REFERENCE: 26/0674

PROPOSAL: CONSTRUCTION OF STABLE BLOCK, IMPROVED ACCESS AND UPDATED ECOLOGICAL ENHANCEMENTS (RESUBMISSION OF REFUSAL 25/0741)

SITE: Land north of and adjacent to St Mary's Church, Church Lane Marshfield Cardiff

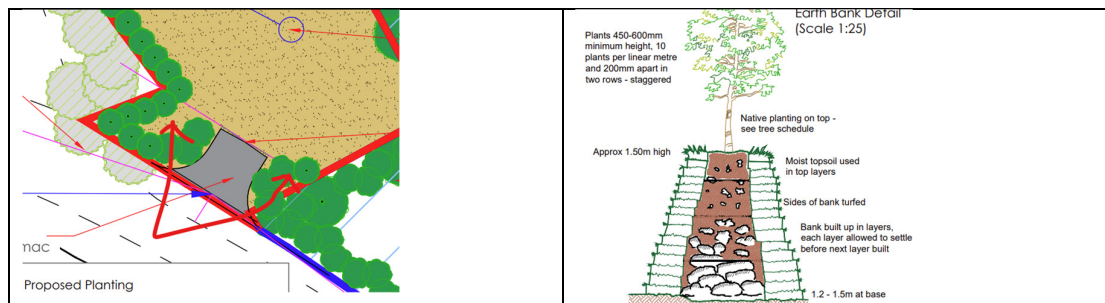
From Church Lane looking north the stables will be open to views, parked vehicles will also be open to view in particular as parking is not defined. It is not clear why the hard surface areas highlighted below are proposed, ideally these would be soft landscape with hedges, trees, grass which would restrict parking/storage etc away from the frontage.
